10 Mb/s Single Twisted Pair Ethernet

10BASE-T1L EEE

(Comments #574, #575, #579, #582)

Steffen Graber
Pepperl+Fuchs

Comment #575: Link Monitor

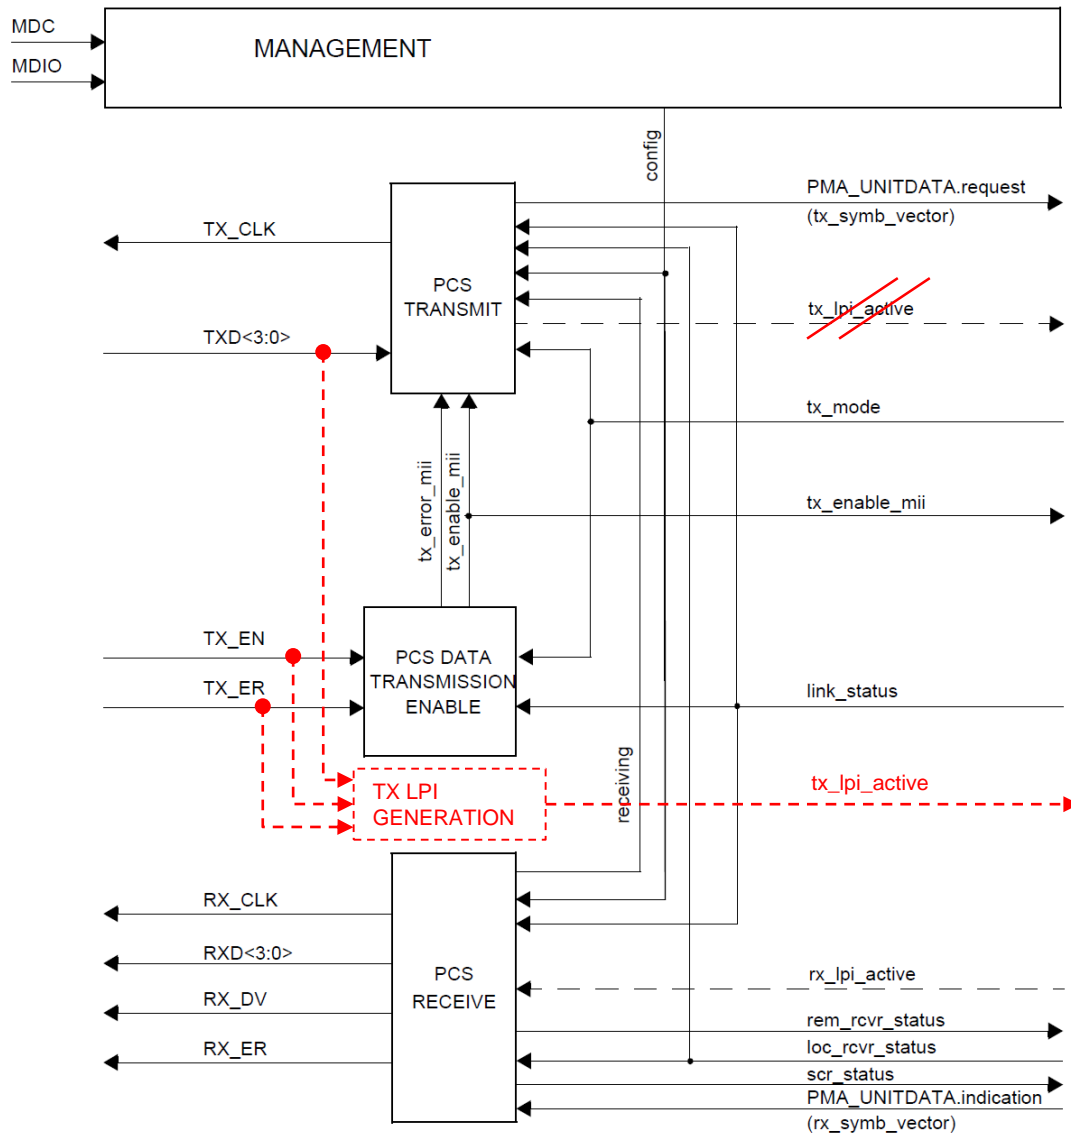
- The Link Monitor state diagram as in draft D2.0 will unintentionally generate a link down, when being in QUIET state.
- This is prevented by adding `(loc_lpi_req = FALSE)` condition as shown above, as the variable `loc_lpi_req` is TRUE in this case (while LPI mode is active).

Comment #579: PCS Reference Diagram

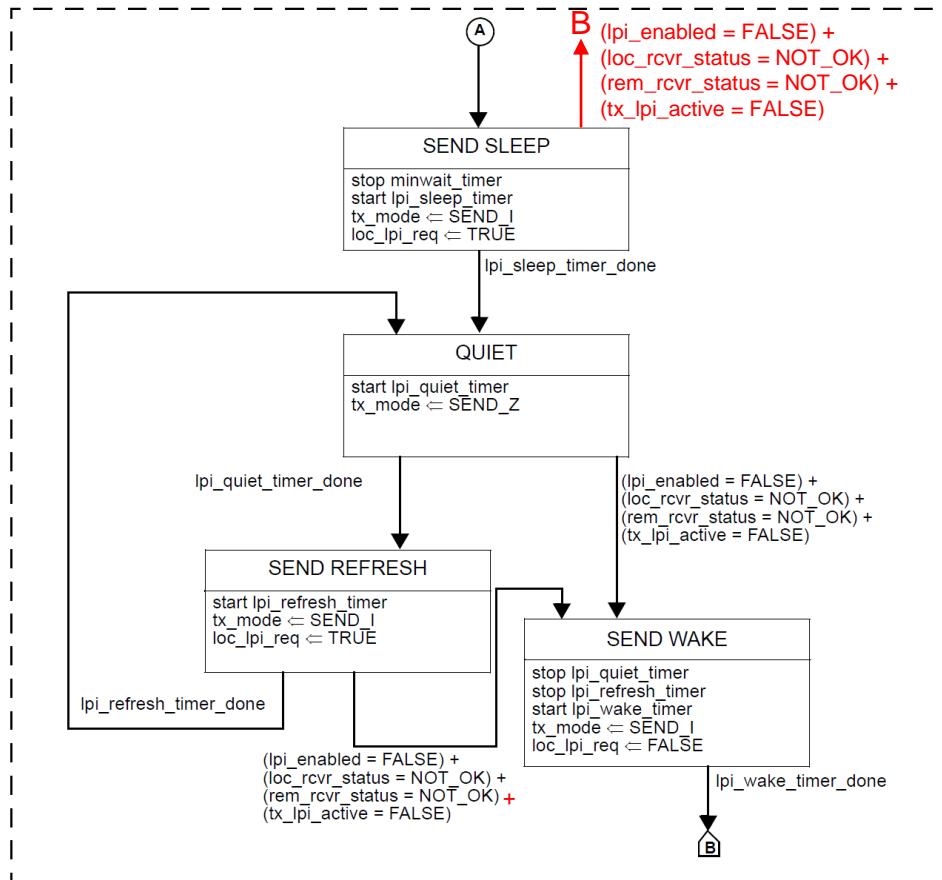
According to the description of variable `tx_lpi_active`, this variable is set to TRUE, if „Assert Low Power Idle“ condition on the MII is active.

Figure 146-3 shows the variable being generated within PCS TRANSMIT, which does not directly get the control signals from the MII.

To match Figure 146-3 to the intended functionality of `tx_lpi_active`, a new functional block „TX LPI GENERATION“ should be added, which directly gets the signals from the MII.
